Return To Library > Records 2 > ERID-105000 Through ERID-105499 > ERID-105038 1) SUBMITTAL OF THE RESPONSE TO THE NOTICE OF DISAPPROVAL FOR THE INVESTIGATION WORK PLAN FOR UPPER CANADA DEL BUEY AGGREGATE AREA AND REVISION 1, 2) NOTICE OF DISAPPROVAL EPA ID NO NM0890010515, HWB-LANL-08-013, LA-UR-08-6121, EP2008-0507, 3) INVESTIGATION WORK PLAN FOR UPPER CANADA DEL BUEY AGGREGATE AREA, REVISION 1, LA-UR-08-6122, EP2008-0508, 4) MAP PLATE 1, 5) ATTACHED CD LA-UR-08-6122, EP2008-0508

Date: September 29, 2008
Refer To: EP2008-0507

Subject: Submittal of the Response to the Notice of Disapproval for the Investigation Work Plan for Upper Cañada del Buey Aggregate Area and Revision 1

Figure 5.12-2 Proposed sampling locations for SWMUs 46-004(b2), 46-004(c2), 46-004(g) (outfall), 46-004(m), 46-004(p), 46-004(s), 46-004(y), 46-004(z), 46-006(a), 46-006(f), 46-007, 46-008(b), and AOCs 46-004(e2) and 46-004(f2)

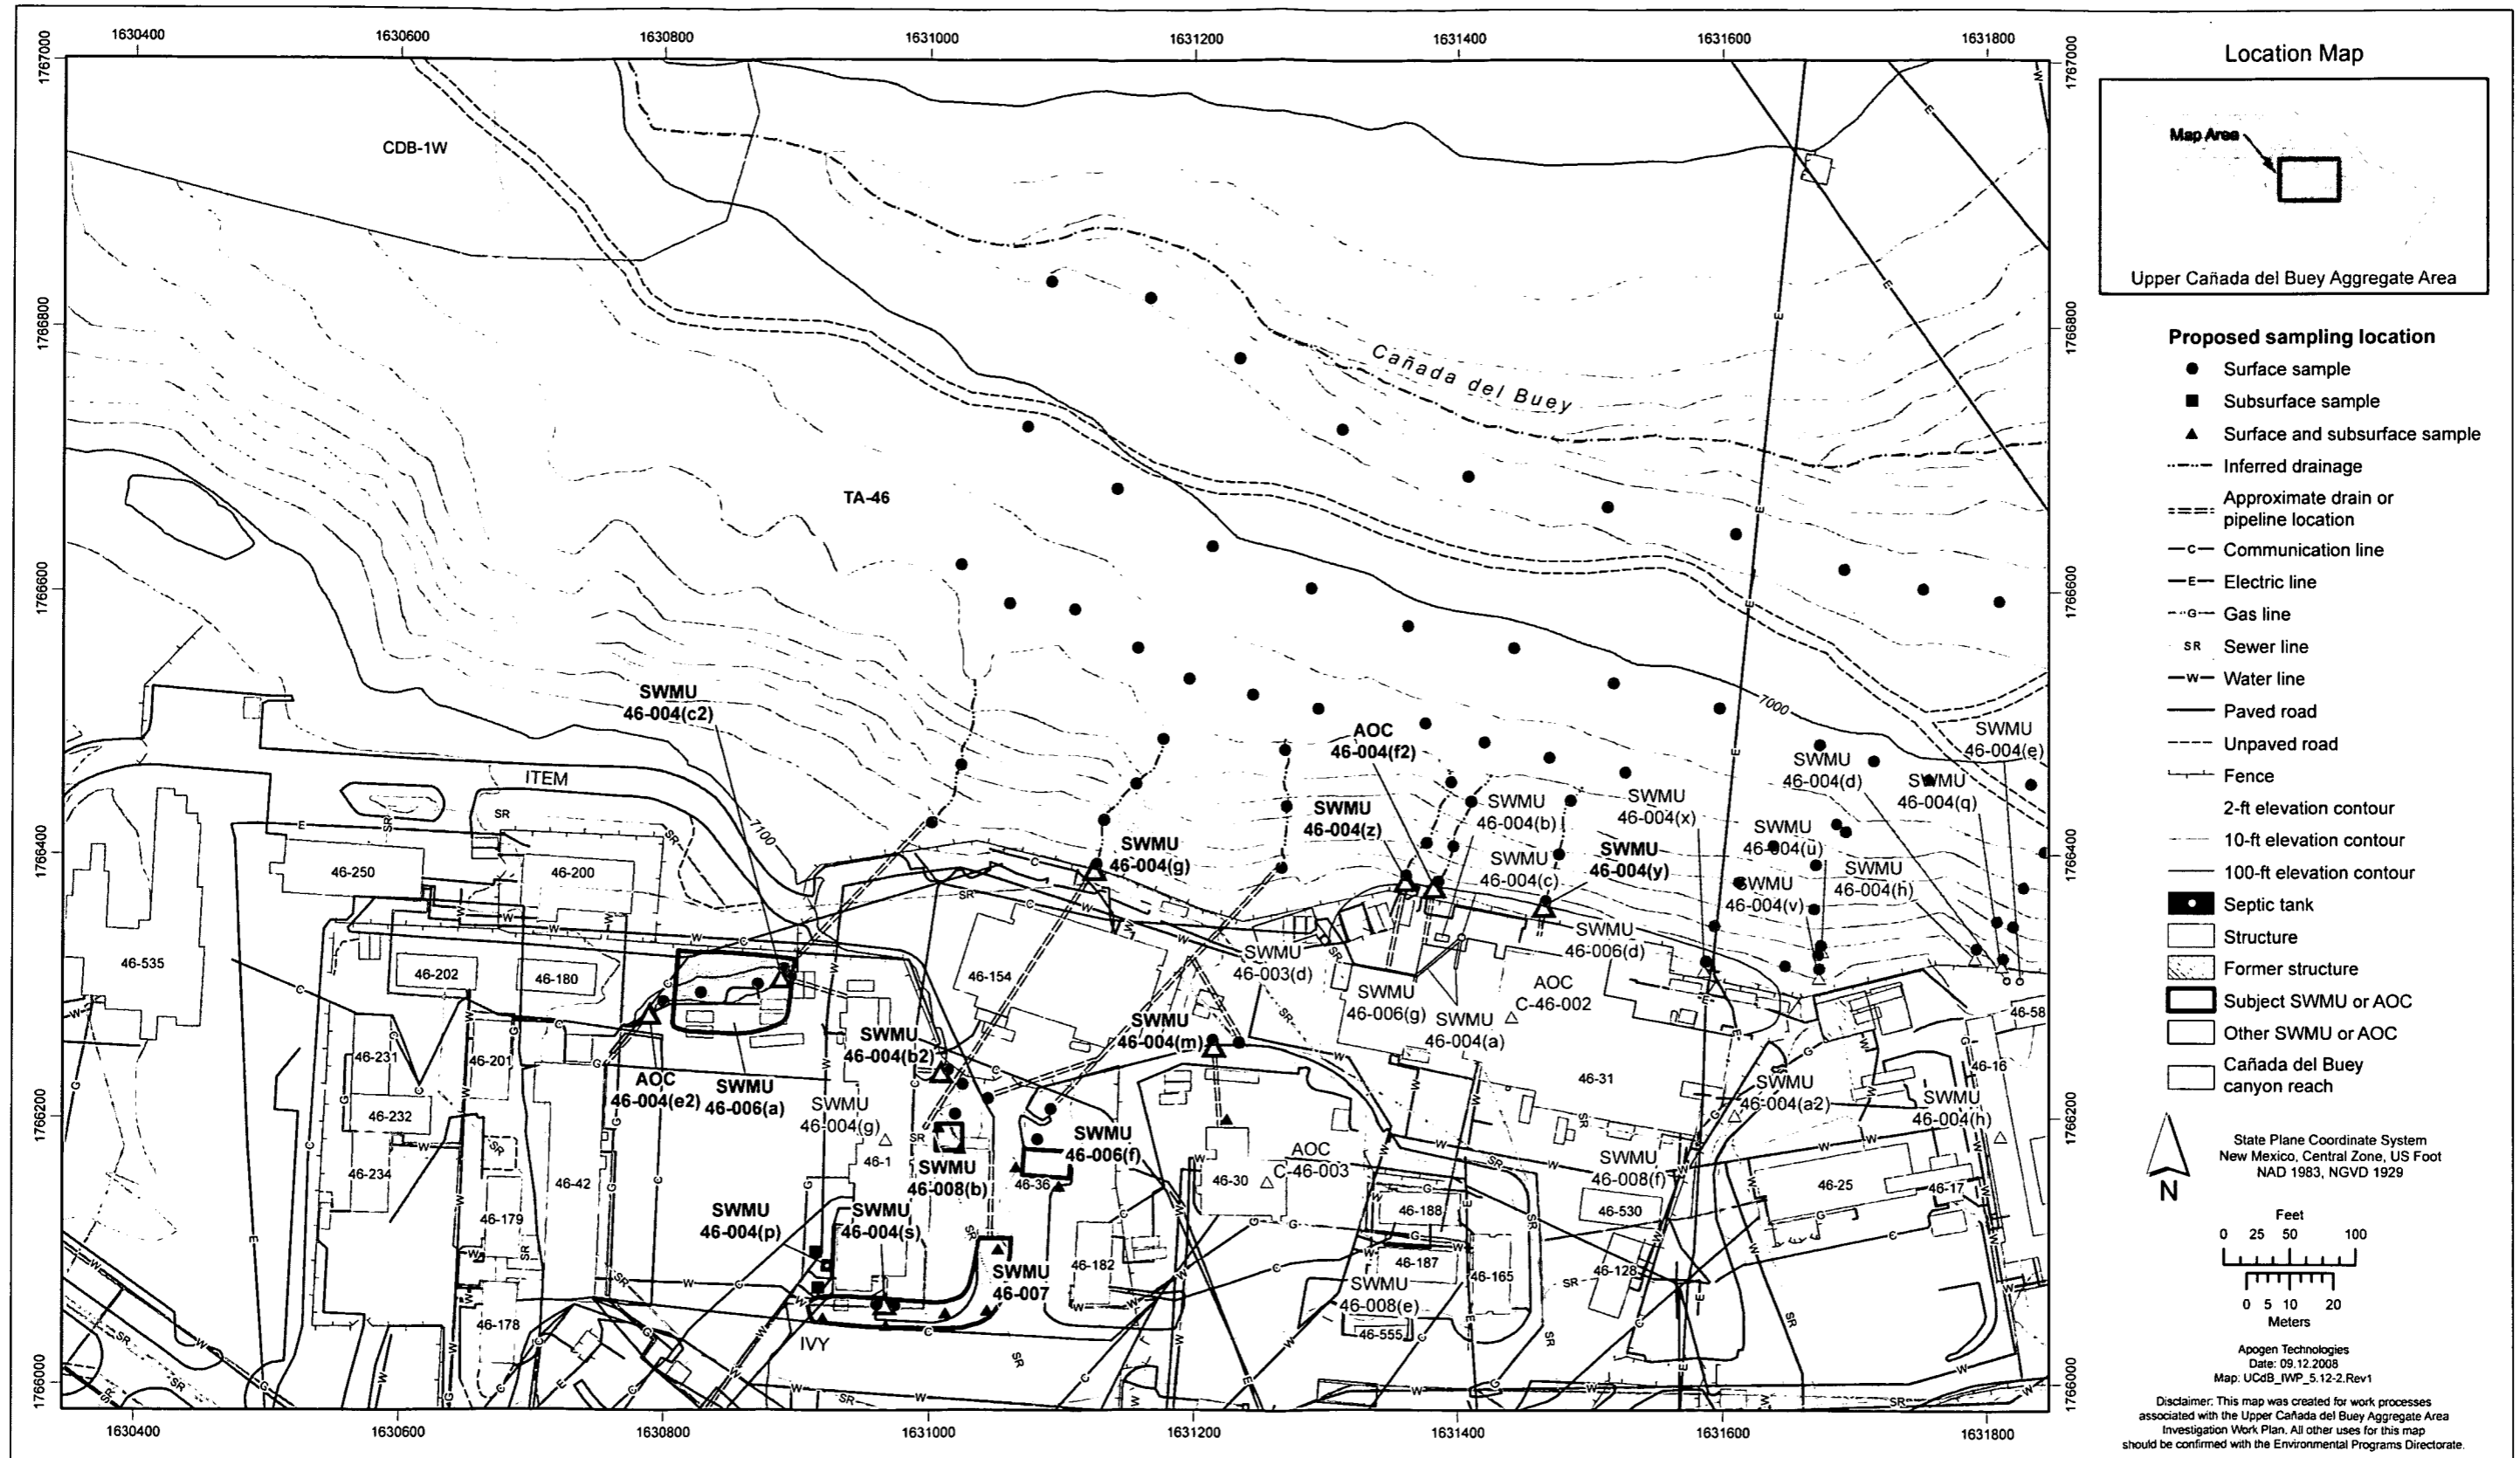
Permittees' Statement: "Twenty samples will be collected from 10 locations in the drainage at and below the outfall (Figure 5.12-2)."

- 16. Figure 5.12-2, page 96:**

- Figure 5.12-2 and the text in section 5.20.3 have been revised to show a new sampling location along the drainline between the SWMU 46-004(m) outfall and building 46-30 and next to the drainline as close as possible to the point where the line exits building 46-30. In addition, one of the proposed sampling locations at the outfall discharge point was moved approximately 6 ft to the east. Samples for these locations will be collected at two depths and analyzed for the same constituents proposed for the other locations at SWMU 46-004(m).

16. Since there are no defined drainage channels below the outfalls of SWMUs 46-004(c2), 46-004(g), 46-004(m), 46-004(z), 46-004(y), 46-004(x), 46-004(u), 46-004(v), 46-004(h), and 46-004(q) and AOC 46-004(f2), Figures 5.10-1 and 5.12-2 have been modified to show proposed sampling locations in transects across the bench areas below the mesa top where sheet flow could carry potential contaminants to the canyon bottom. The sampling locations associated with individual SWMUs and AOCs shown in these figures have been revised based on the new hillside transect sampling approach agreed upon with NMED during the August 2008 site visit. Sampling locations previously sited in the canyon bottom were relocated to the toe of the slope as part of the hillside transect sampling approach (see also the crosswalk table, the revised work plan text, and Table 4.0-1).
